FACPAC Contract Change Order

Tier 1 Project: Estill Springs Elementary Phase 2 Renovations & Addition - ESSER III
 BG Number: 22-207 District: Estill County (HB678)
 Status: Active Phase: Project Initiation (View Checklist)

THE CONTRACT IS CHANGED AS FOLLOWS:
 PR #6 - New Pre-fabricated canopy with linear lighting

PR.06 - PREFAB CANOPIES

CANOPY LIGHTING PLAN

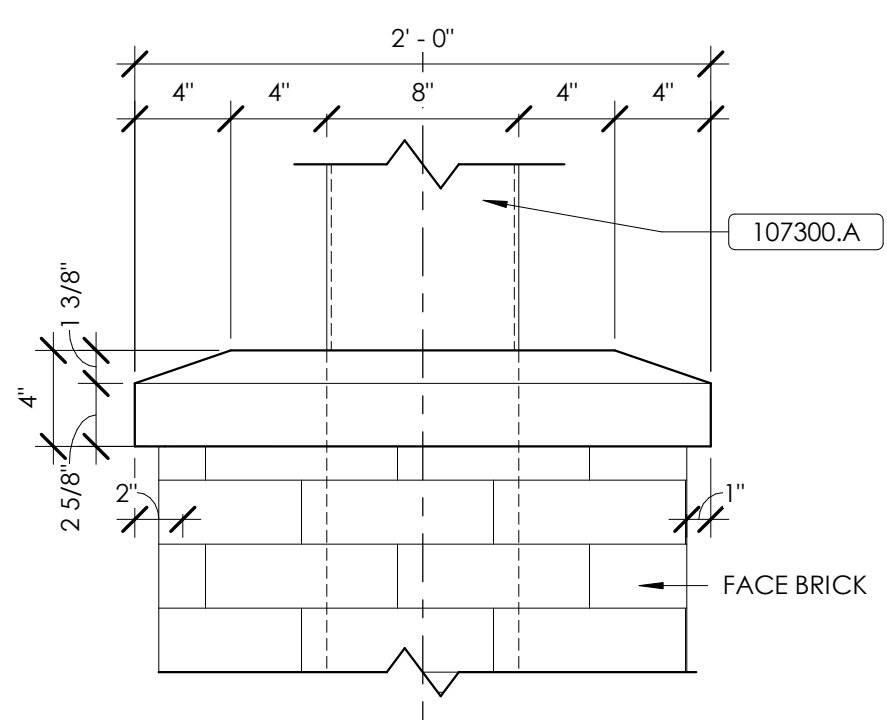
PR #6 - New pre-fabricated canopy with linear lighting.

1. A new pre-manufactured canopy with linear lighting.
2. New masonry column wraps itemized separately.
